REVISION A HV REG SER #81221 ON

CT/C-7A/C-7A 'REVISED' POWER SUPPLY

EFFECTIVE TO SERIAL NO. 81220 (HIGH VOLTAGE ONLY)
SERIAL NO 81221 ON USE REVISION A (HIGH VOLTAGE ONLY)

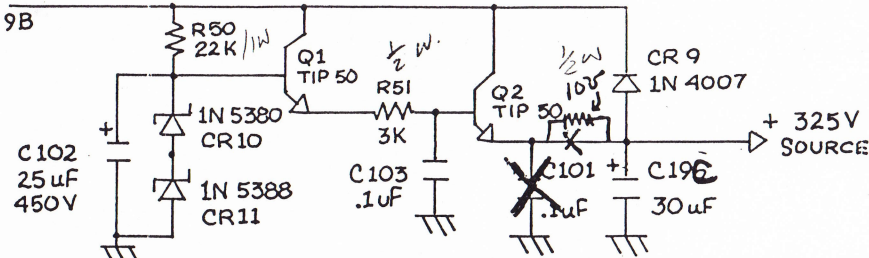
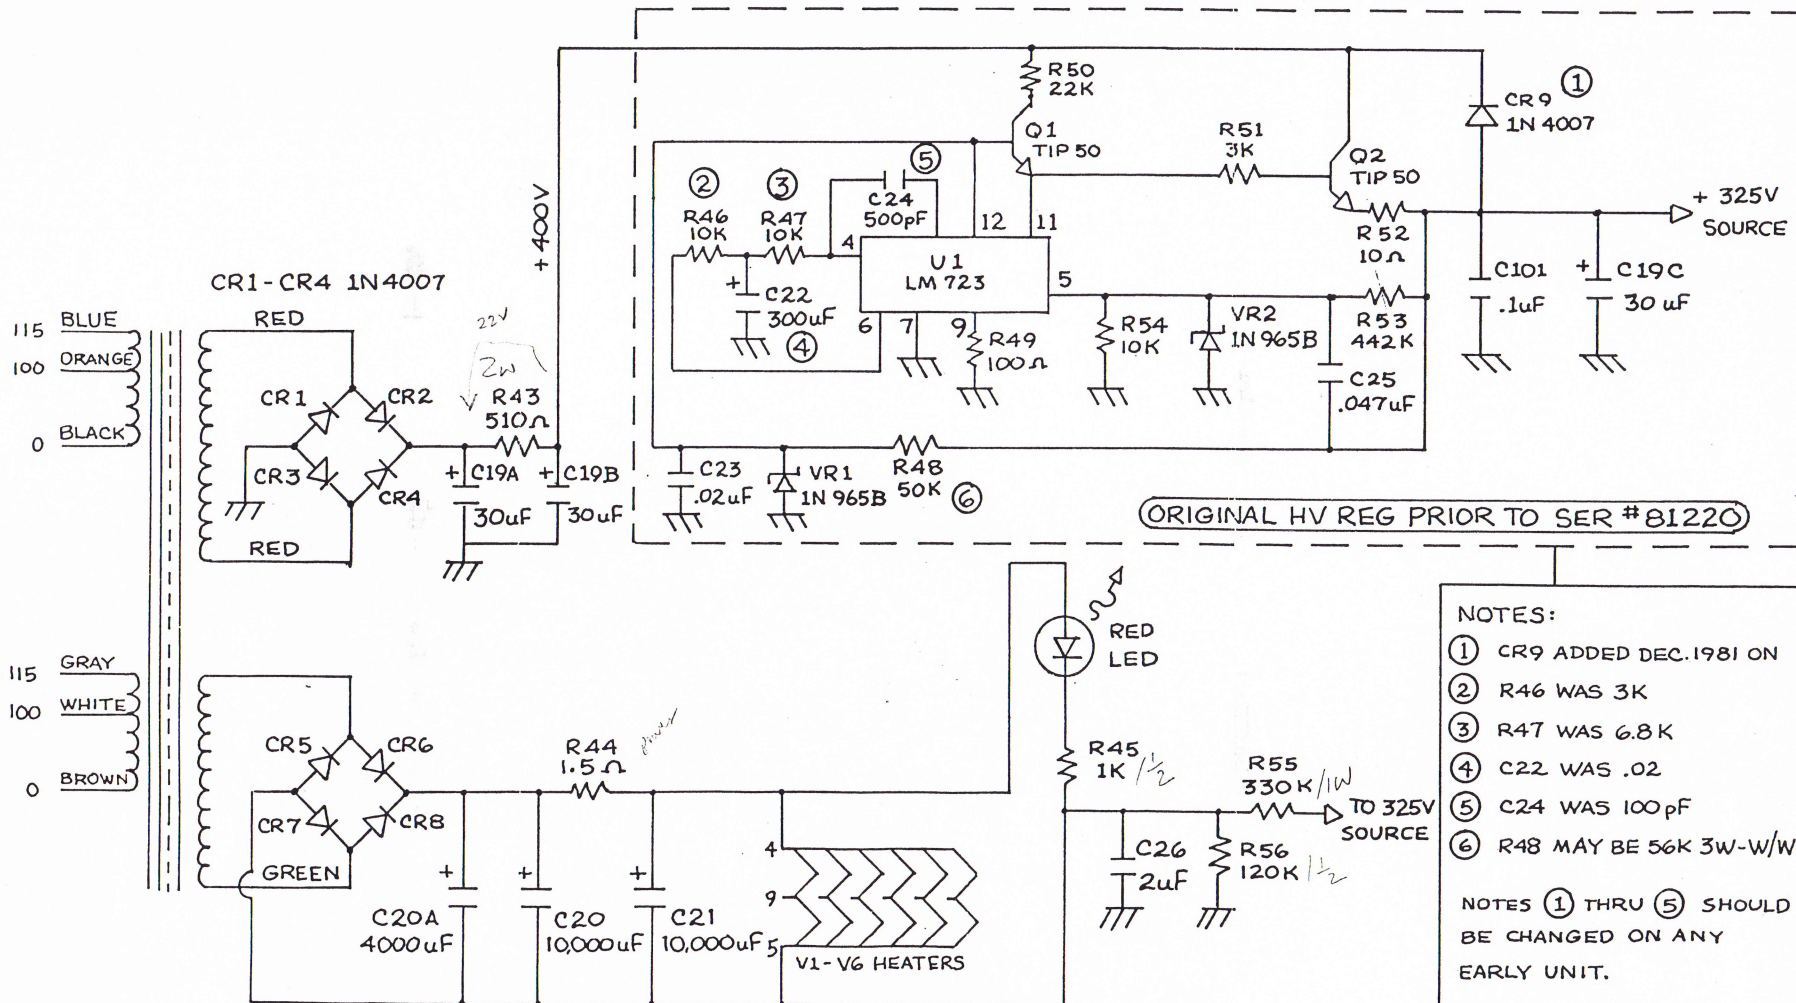
ADD:

- C102 25 uF 450V ELECTROLYTIC
- C103 .1uF 600V CERAMIC DISC
- CR10 1N 5380 120V 5W ZENER DIODE
- CR11 1N 5388 200V 5W ZENER DIODE

DELETE:

- V1, VR1-2
- R46 THRU R49
- R52 THRU R54
- C22 THRU C25

REASONS FOR CHANGES { • INCREASED RELIABILITY
• IMPROVED SOUND QUALITY
